[Docket No. FAA-2011-0054; Directorate Identifier 2010-CE-070-AD; Amendment 39-16582; AD 2011-01-53]

#### Airworthiness Directives; PIAGGIO AERO INDUSTRIES S.p.A Model PIAGGIO P-180 Airplanes

**ACTION:** Final rule; request for comments.

**Figure 1. Additional drain holes on keel beam webs**

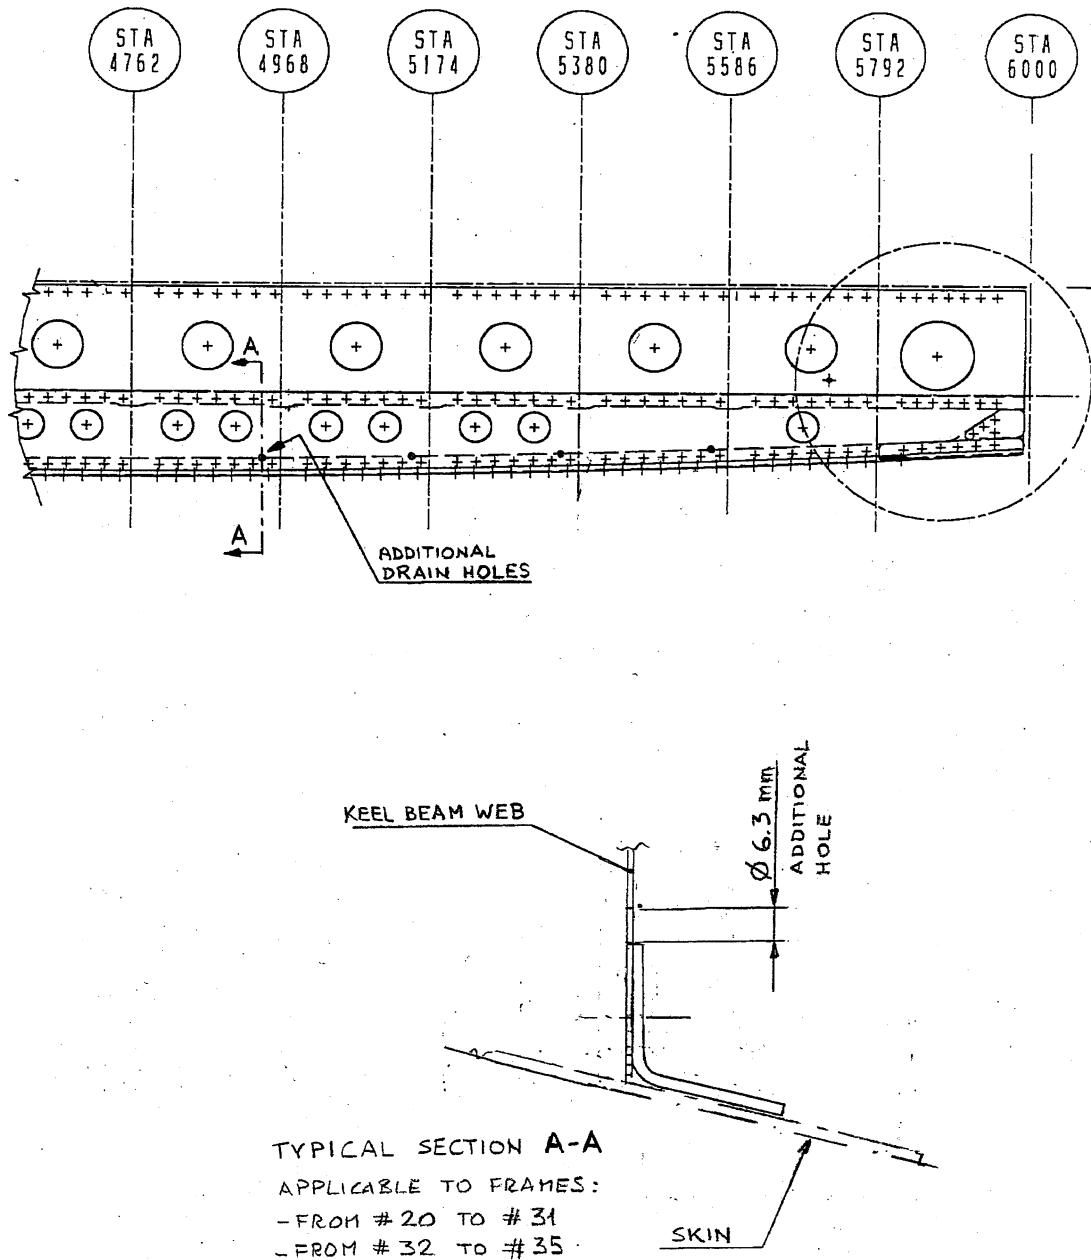
5. Add 6.3 mm draining holes as per attached figure 1 (additional drain holes on keel beam webs) connecting the lateral bays to the center ones or, as alternative, apply Piaggio Aero Industries Service Bulletin 80-0291. Then proceed with step 6.

**Figure 2. Fuselage Drain Holes**

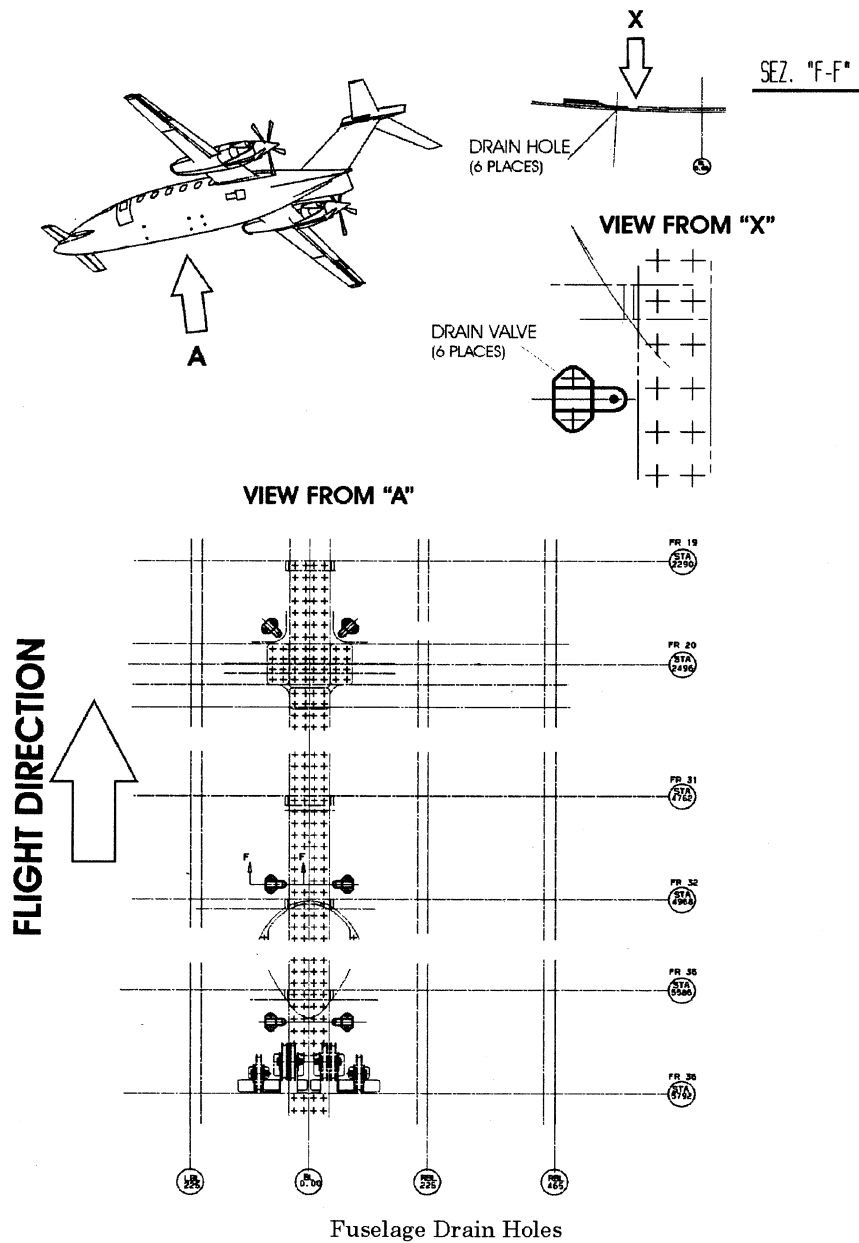
After we issued Emergency AD 2011-01-51, we realized that we inadvertently omitted figure 2 in Appendix 1. This prompted us to supersede Emergency AD 2011-01-51 and issue Emergency AD 2011-01-53.

We are superseding Emergency AD 2011-01-51 with a new AD, which was issued as Emergency AD 2011-01-53 on December 20, 2010. This AD retains the actions from Emergency AD 2011-01-51, adds figure 2 to Appendix 1, and corrects other minor typographical errors.

- a. Place an adequate amount of water in each bay between FR 19 and FR 36 (See figure 2) to verify that the water is conveyed in the central bays and that it is drained. Use at least ½ gallon (approximately 2 liters).  
**NOTE: TAKE CARE NOT TO COME IN CONTACT WITH ELECTRICAL CONNECTORS WHILE POURING WATER.**
- b. A steady stream of water should be observed coming from the external drain holes. If not, the flapper valve does not drain properly. Cut off the rubber flap and replace the flapper valve at next A check. Take note of any cut rubber flap and its position.
13. Dry the fuselage belly.
